# UNITED STATES PATENT AND TRADEMARK OFFICE

APPLICATION NO.	FILING DATE	FIRST NAMED INVENTOR	ATTORNEY DOCKET NO.	CONFIRMATION NO.
10/824,229	04/14/2004	Keishi Inoue	09792909-5867	6345
26263	7590	11/02/2005	EXAMINER	
SONNENSCHN NATH & ROSENTHAL LLP			DOAN, THERESA T	
P.O. BOX 061080			ART UNIT	
WACKER DRIVE STATION, SEARS TOWER			PAPER NUMBER	
CHICAGO, IL 60606-1080			2814

**Office Action Summary**

## **DETAILED ACTION**

FIG. 4

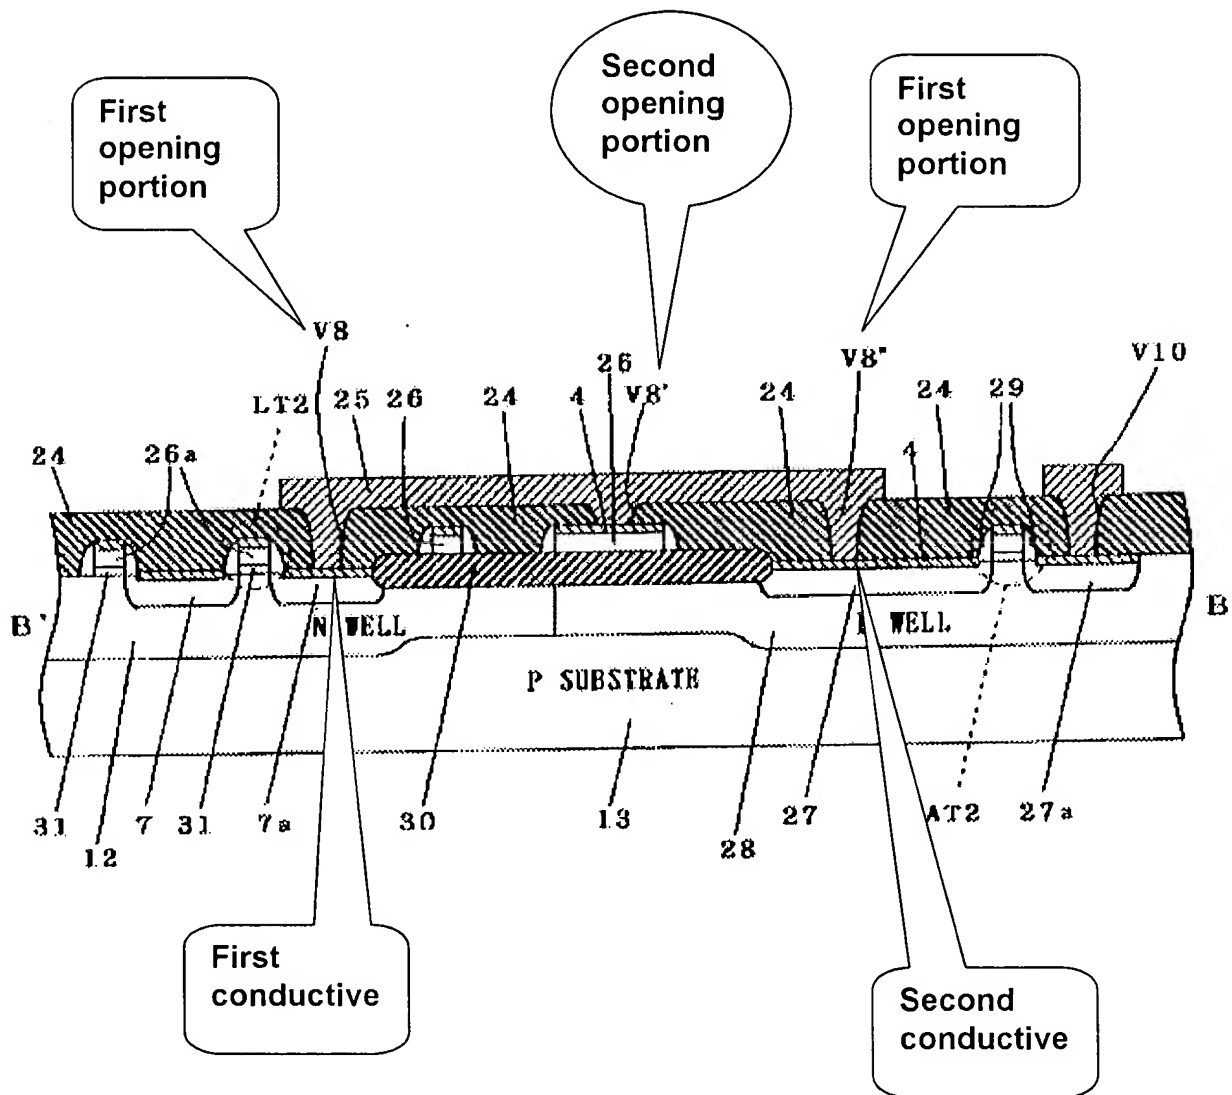
Regarding claim 1, Matsumoto (Fig. 4) discloses a semiconductor device comprising:

a first conductive layer 4 formed on the substrate 13 (See Fig. 4 Labeled by Examiner below and column 7, lines 18-21);

a second conductive layer 4 formed on the substrate 13 (also see Fig. 4 Labeled by Examiner below and column 7, lines 30-32) at a predetermined distance from the first conductive layer 4;

an insulation film 24 (column 7, line 38) formed on upper surfaces of the first conductive layer 4 and the second conductive layer 4 and having a plurality of first opening portions (V8/V8") (column 7, lines 41-43) to expose either the first conductive layer 4 or the second conductive layer 4 and one or more second opening portions V8' (column 7, lines 41-43) to expose neither the first conductive layer 4 formed at the first opening portion V8 nor second conductive layer 4 formed at the first opening portion V8"; and

a third conductive layer 25 (column 7, line 39) formed on an upper surface of the insulation film 24 (column 7, lines 38-39) in such a manner to fill up the first opening portions (V8/V8") and the second opening portions V8' for making electrical connection between the first conductive layer 4 and the second conductive layer 4 by way of the first opening portions (V8/V8");

wherein the second opening portions V8' are formed between a pair of the first opening portions (V8/V8") along the third conductive layer 25 (See Fig. 4 Labeled by the Examiner below).

Regarding claim 2, Matsumoto discloses that the second opening portions V8' are formed at a predetermined distance between the first opening portions (V8/V8").

Regarding claim 4, Matsumoto (Fig. 4) discloses a semiconductor device comprising: a substrate 13 (column 6, line 23); a first conductive layer 4 formed on the substrate 13 (column 7, lines 18-21); a second conductive layer 4 formed on the substrate 13 (column 7, lines 30-32) at a predetermined distance from the first conductive layer 4; an insulation film 24 formed on upper surfaces of the first conductive layer 4 and the second conductive layer 4 and having a plurality of opening portions (V8/V8") (column 7, lines 41-43) to expose one end portion of the first conductive layer 4 or of the second conductive layer 4; and a third conductive layer 25 formed on an upper surface of the insulation film 24 (column 7, lines 38-39) in such a manner to fill up the opening portions (V8/V8") for making electrical connection between the first conductive layer 4 and the second conductive layer 4 (See Fig. 4 above); wherein the third conductive layer 25 has a predetermined wiring length to maintain the connection, and has the electrical connection between the first conductive layer and the second conductive layer 4 at both ends of the third conductive layer 25 by way of the opening portions (V8/V8"). It is noted that where the claimed and prior art products are identical or substantially identical in structure or composition or are produced by identical or substantially identical processes, claimed properties or functions are presumed to be inherent. In re Best, 195 USPQ 430, 433 (CCPA 1977). Therefore, if the prior art teaches the identical structure, the properties applicant discloses and/or claims are necessarily present. In re Spada, 15 USPQ2d 1655, 1658 (Fed. Cir. 1990). In this case, the third conductive layer 25 would inherently have properties of maintaining the connection even if the length of the third conductive layer in a direction of longer length

changes due to thermal expansion or contraction because the forming of a second opening portion V8' between the first opening portions V8 and V8" would help to disperse the force resulting from the change in the wiring length of the third conductive layer 25.
